COMAL COUNTY

Permit of Authorization to Construct an On-Site Sewage Facility Permit Valid For One Year From Date Issued

Permit Number: 118152
Issued This Date: 01/22/2025
This permit is hereby given to: Truly Investments LLC

RE: *1920 Split Mountain*
The Vistas at Mountain Springs Ranch 1
Lot 136

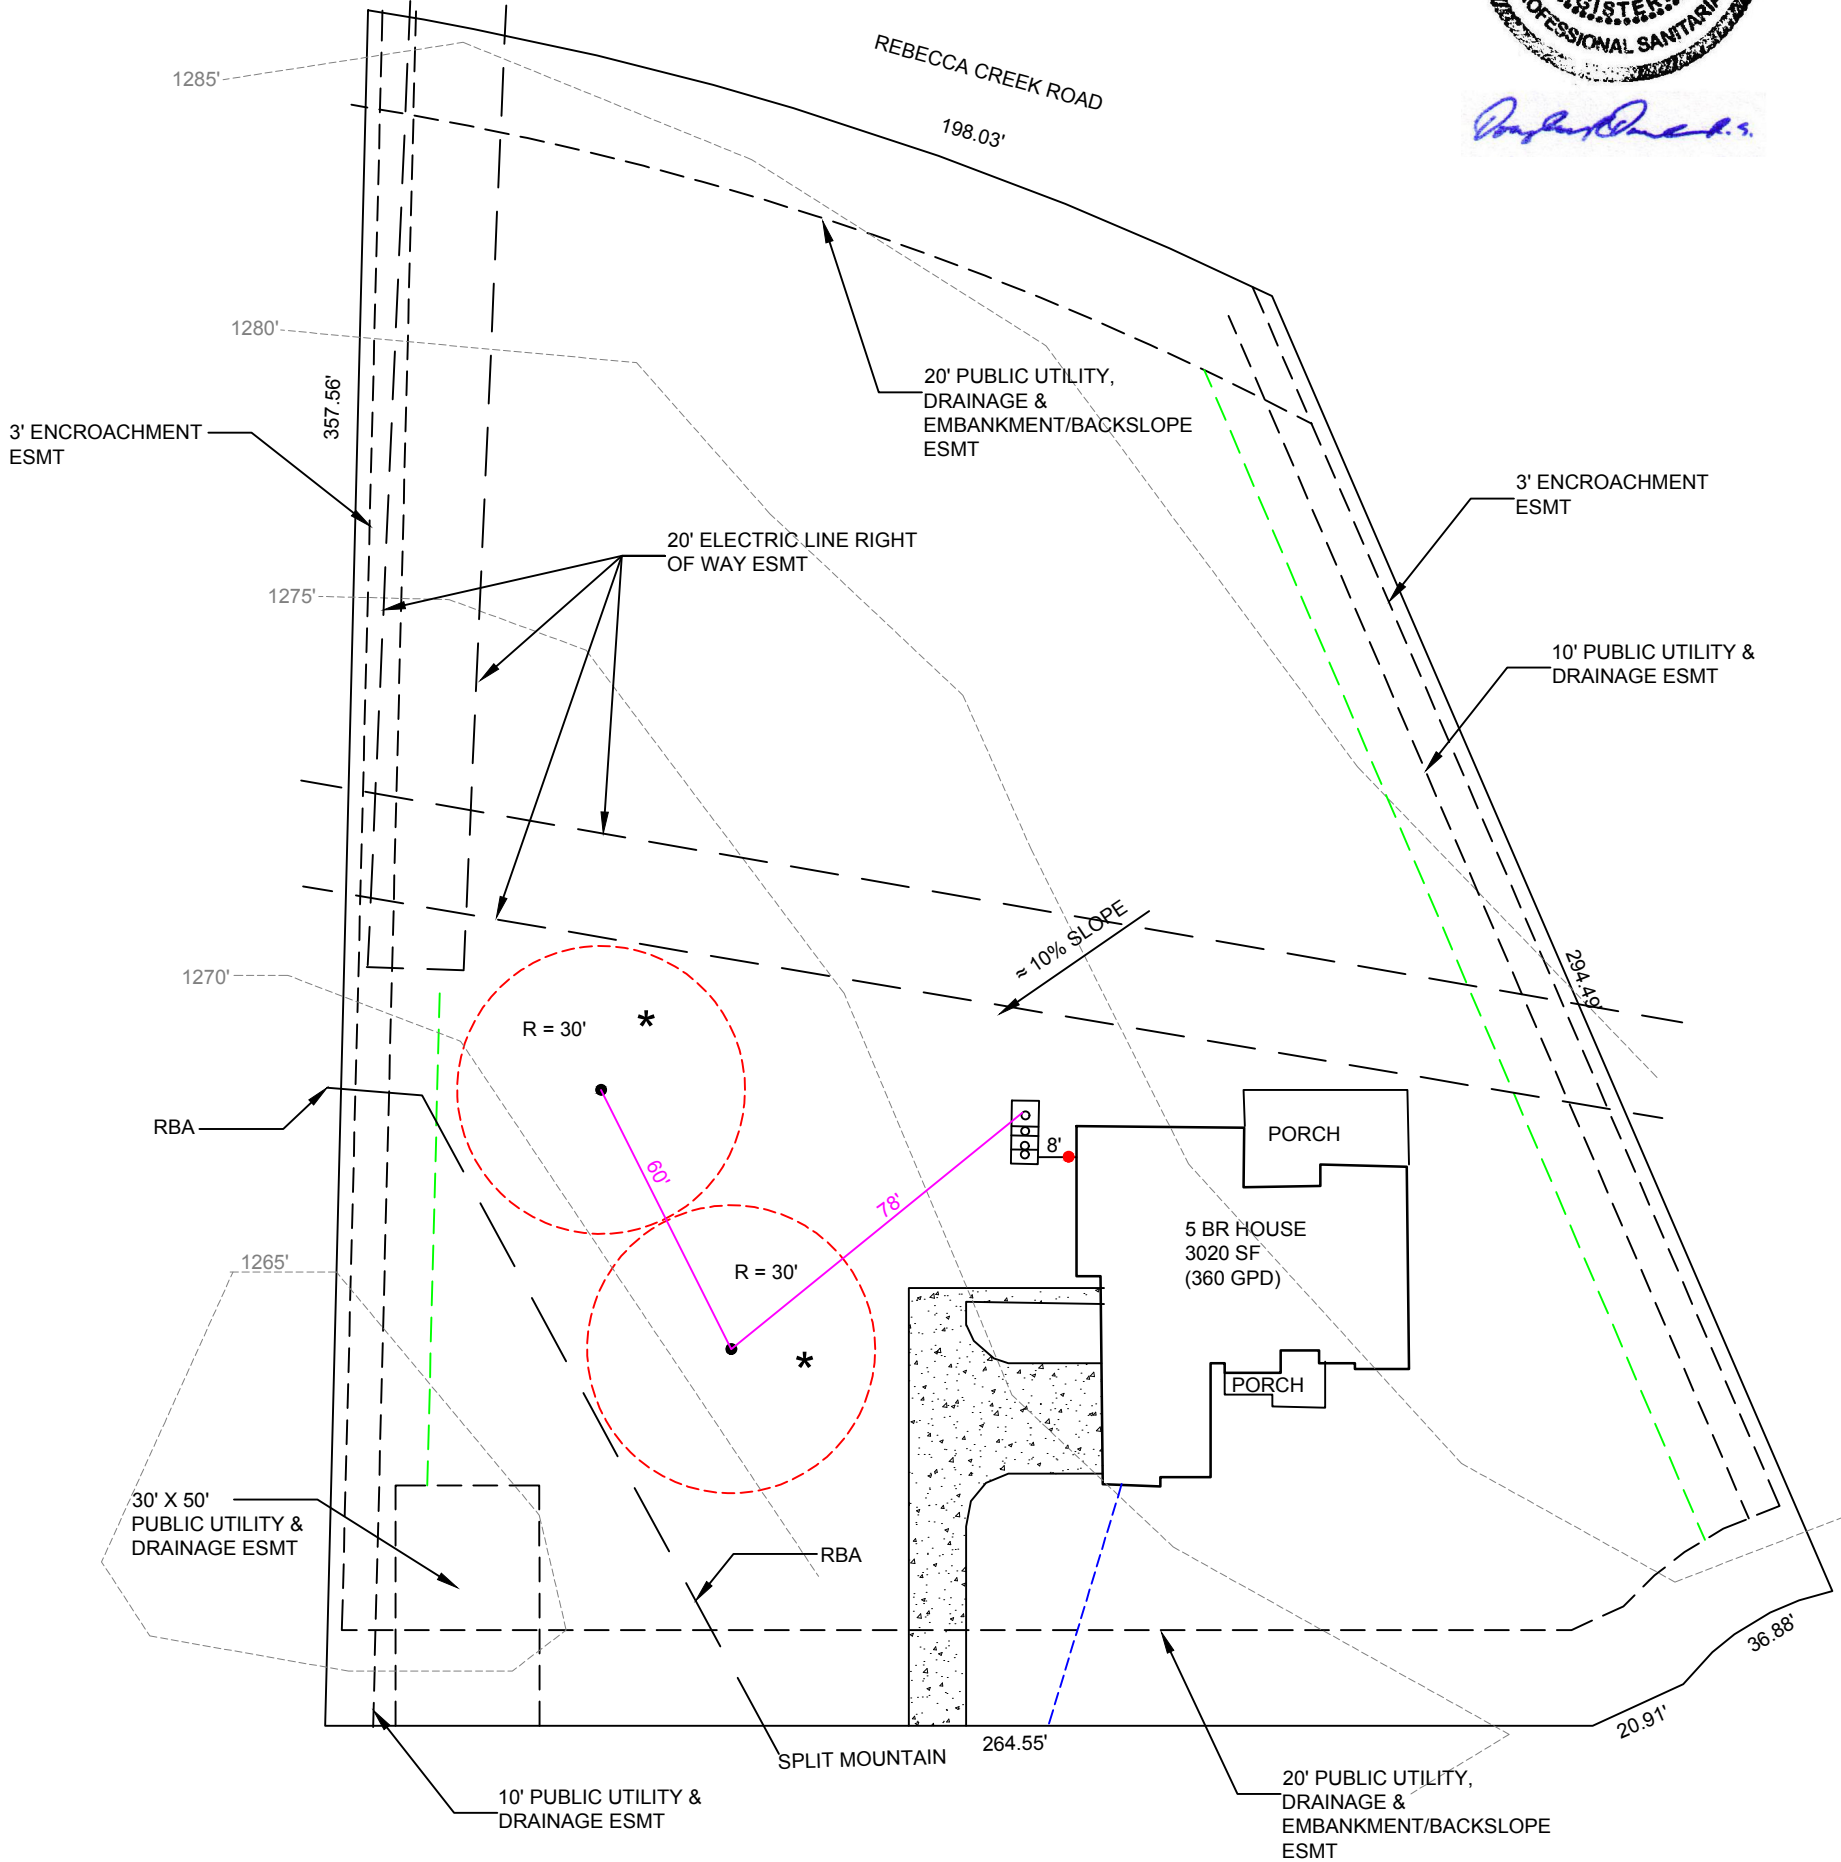
- ✓ Application Page 2:
 - a. I am not seeing a TCEQ approved CZP for the property,
 - b. Is a CZP required?
- ✓ Site Plan:
 - a. Show the 20ft wide electric line easement.
 - i. Maintain necessary setback requirements 285.91(10)
 - b. Show the RBA
- 3. Revise accordingly and resubmit.

- NOTES:**
- 1" SCH 40 PURPLE PIPE TO ALL SPRAY HEADS.
 - 3" OR 4" SCH 40 PVC PIPE FROM STRUCTURE TO TANK.
 - SEWER PIPE CONNECTING THE STRUCTURE TO THE TANK MUST HAVE AT MINIMUM 1/8" FALL PER 1'.
 - TANK TO BE > 5' FROM STRUCTURES AND SURFACE IMPROVEMENTS. THIS WILL PROVIDE EQUIVALENT PROTECTION FOR THE SETBACK REQUIREMENTS OF TAC 285.
 - CLEANOUT WITHIN 3' OF STRUCTURE.
 - TOTAL SPRAY AREA = 5654 SF.
 - TANK WILL BE WATER TIGHT AND MANUFACTURED ACCORDING TO ASTM DESIGNATION: C 1227.
 - DRAINFIELD SHALL BE GREATER THAN 100' FROM PRIVATE WELLS, AND GREATER THAN 150' FROM PUBLIC WELLS. VERIFY WELL LOCATION(S) ON SITE.
 - SPRAY HEADS SHALL BE LOCATED AT LEAST 10' AWAY FROM TREES WITHIN THE DISTRIBUTION AREA.
 - THIS DESIGN MEETS THE OSSF REQUIREMENTS OF THE EXISTING CZP

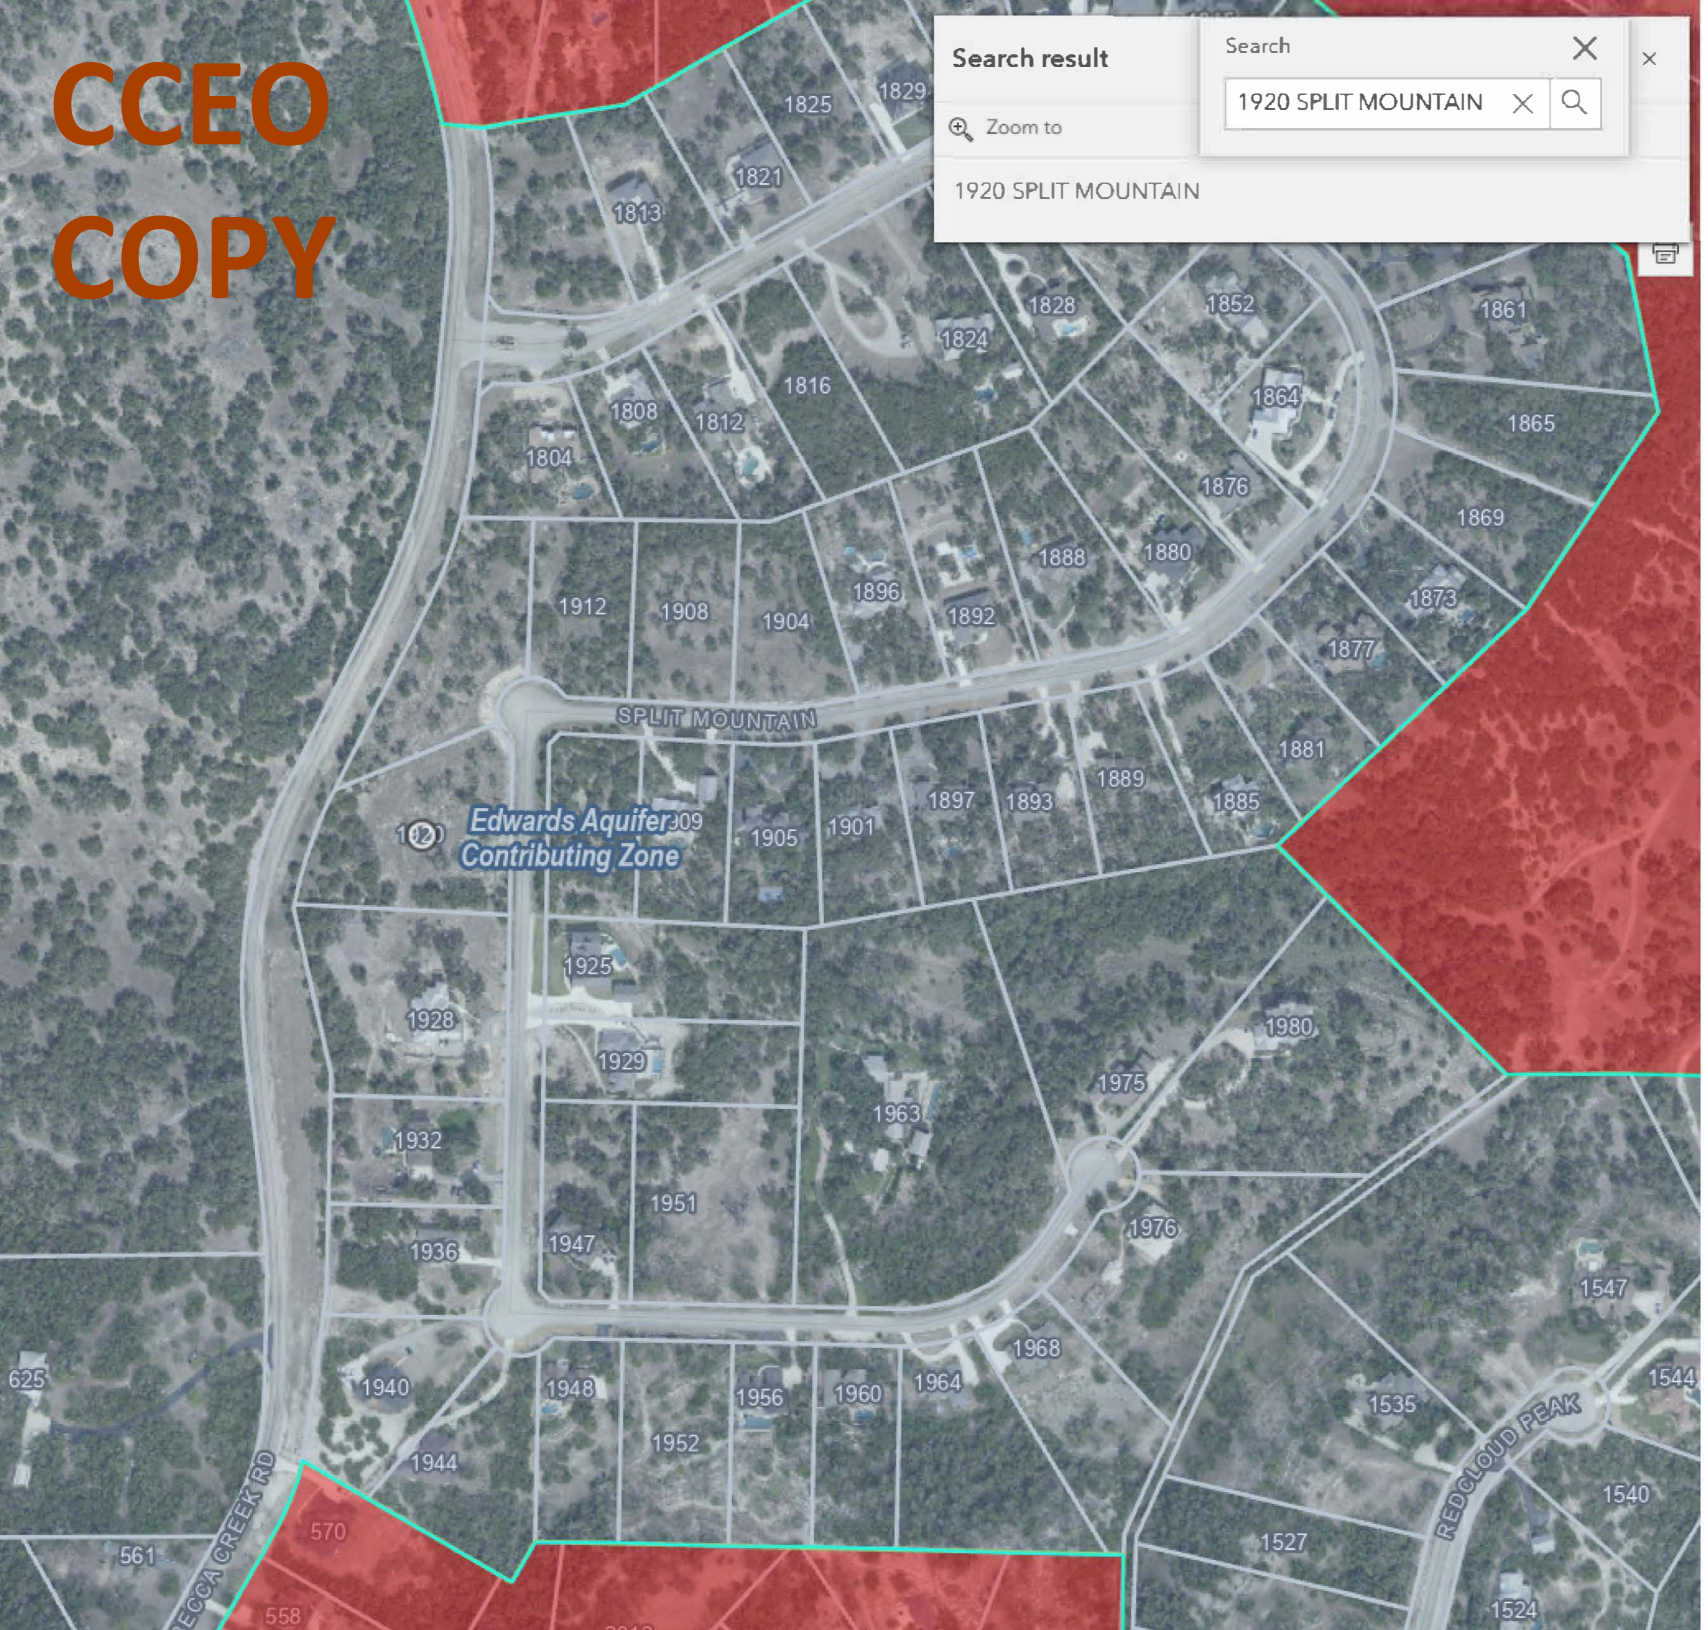
Lauren, attached is a screen shot from our CZP map. The Edwards Aquifer Authority has the regulations for the CZPs. The designer can read through the requirements and determine if one is needed.
